Immingham Green Energy Terminal

10.8 Proposed Further Change Application Report

Document Reference: TR030008/EXAM/10.8

SAFETY, HEALTH AND ENVIRONMENTAL INFORMATION BOX

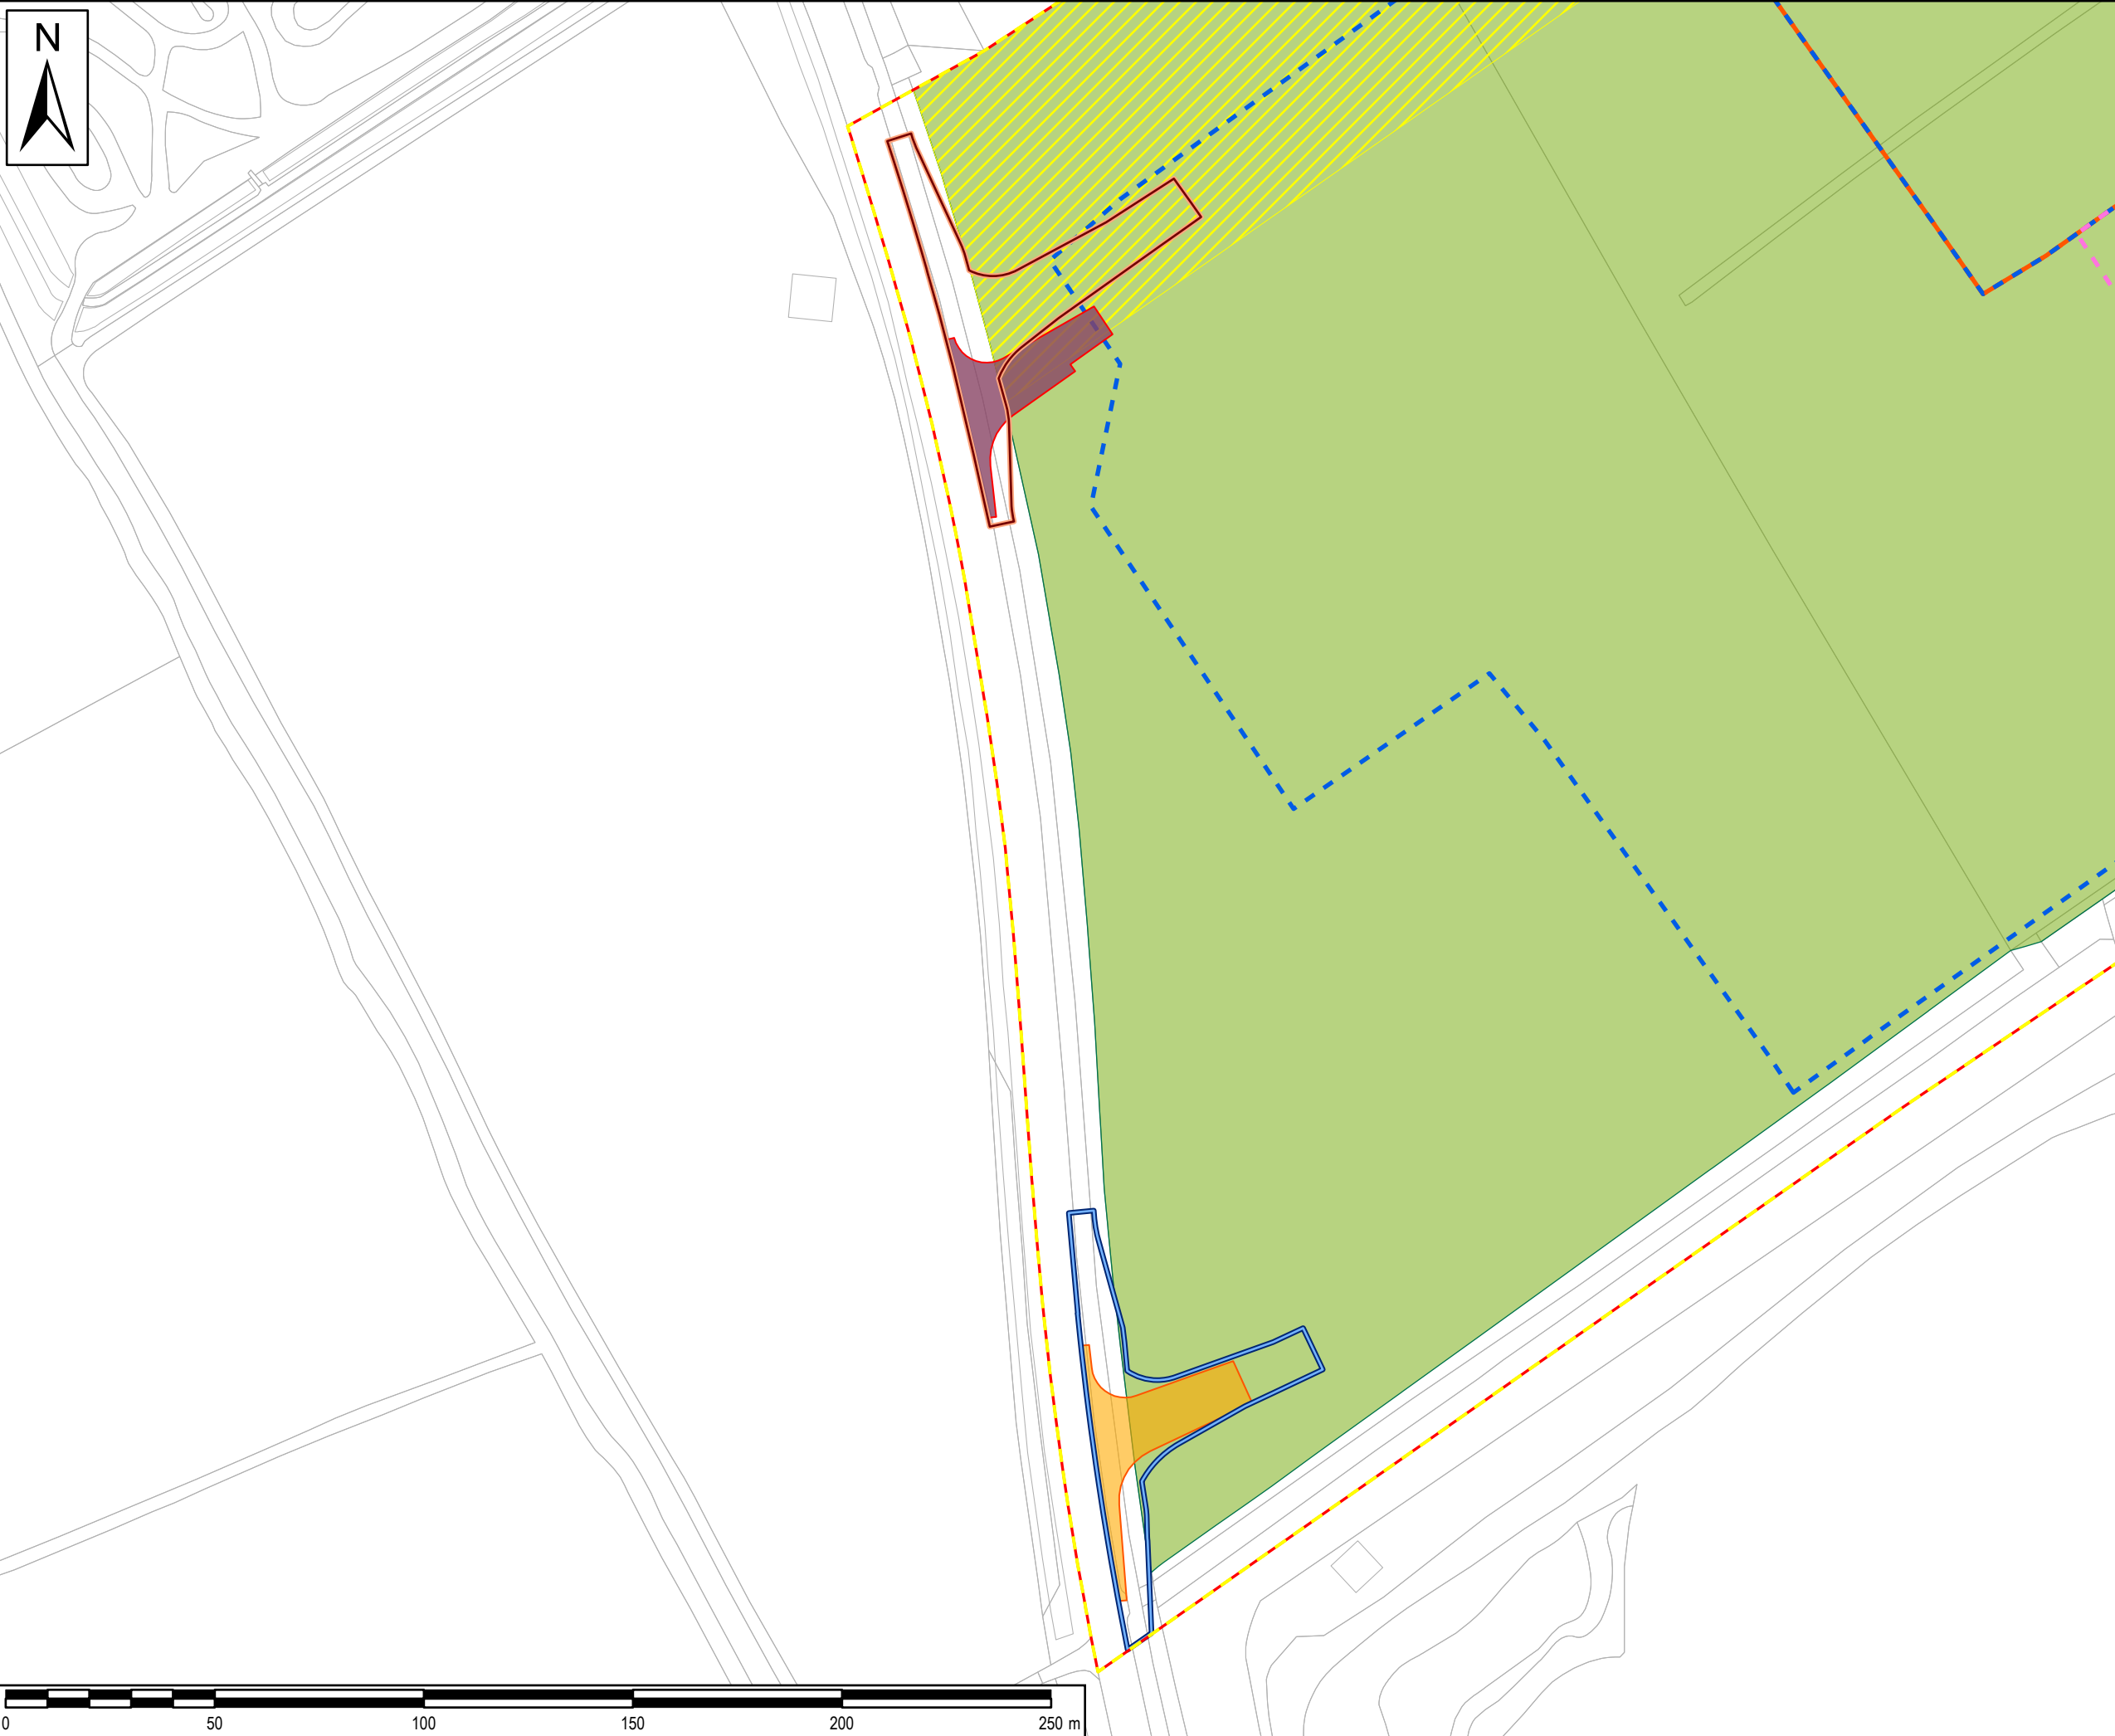
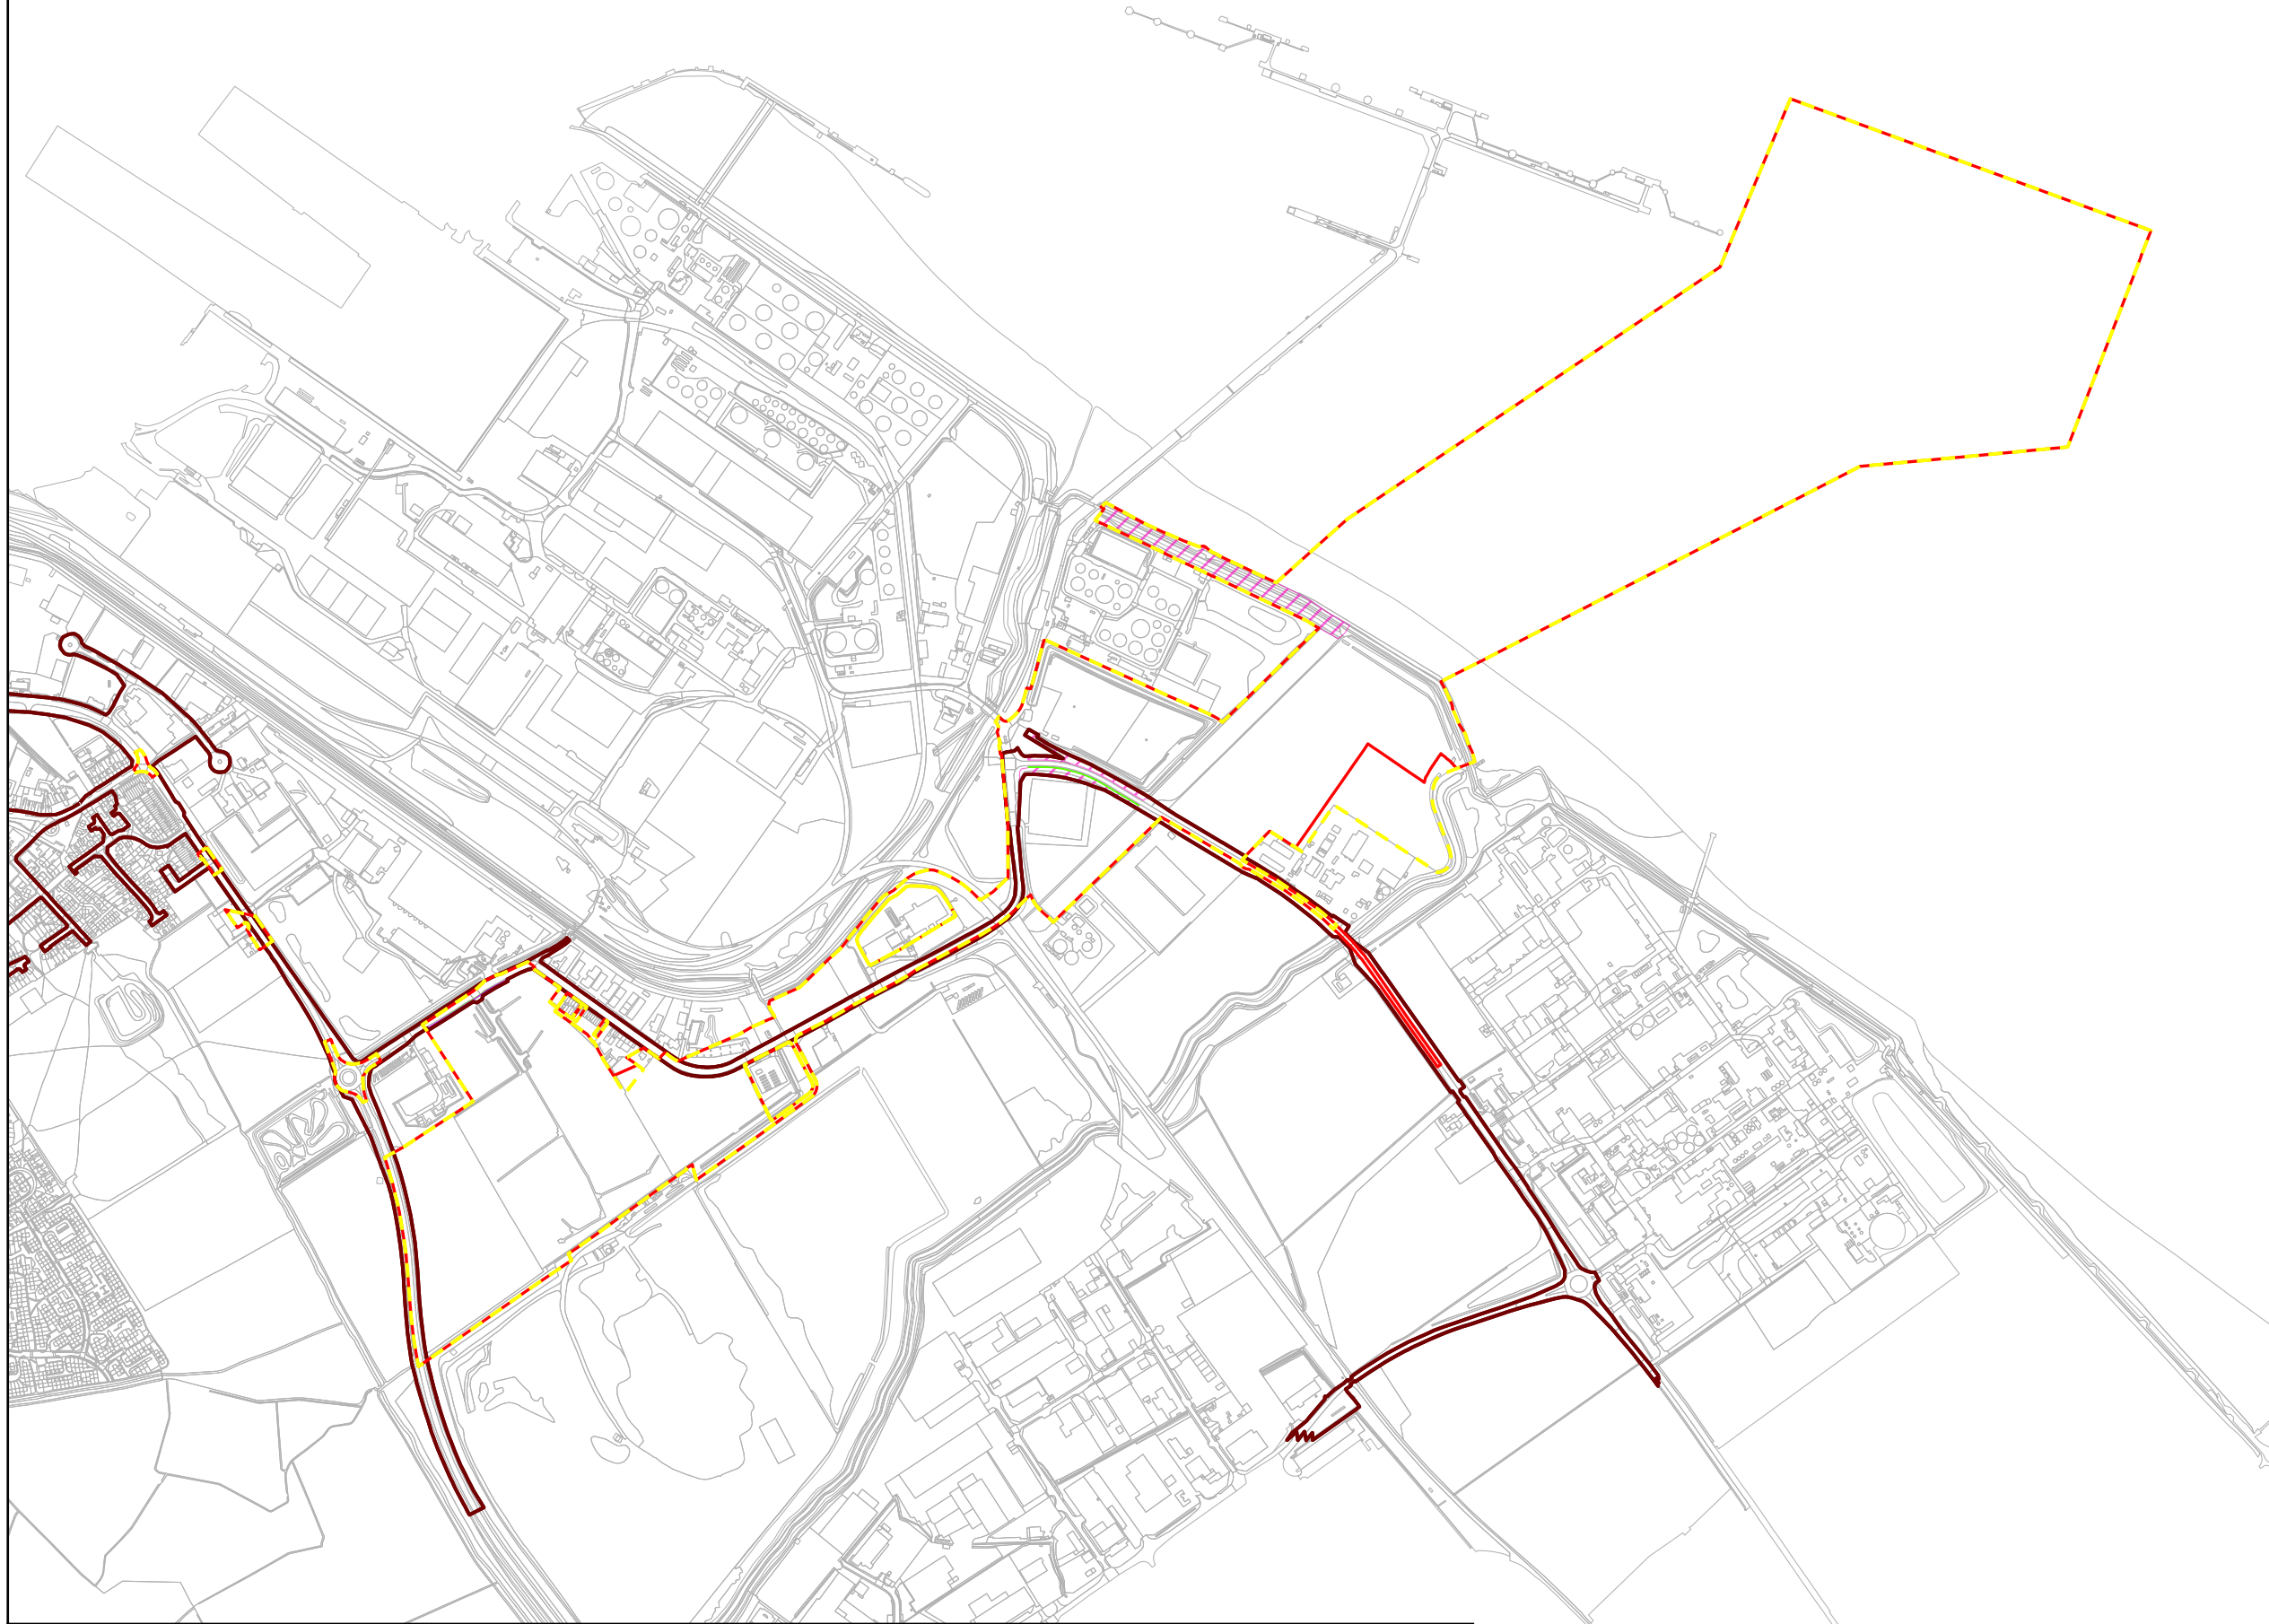
2.6.3 **Appendix 1** illustrates the location of the proposed change and **Appendix 2** illustrates the reduction in the Order limits as a result of the reduction in the area of Work No. 9.

2.6.4 The implementation of this change would result in alterations to the **Works Plans [TR030008/APP/4.2(4)]** and **Land Plans [TR030008/APP/4.5(3)]** (reducing the extent of plots 4/28 and 4/32). It would also involve consequential changes to other Application documents (which have been submitted as part of this Proposed Further Change Application and are listed at **Appendix 12**) as a result of the reduction of the Order limits and extent of temporary possession powers sought.
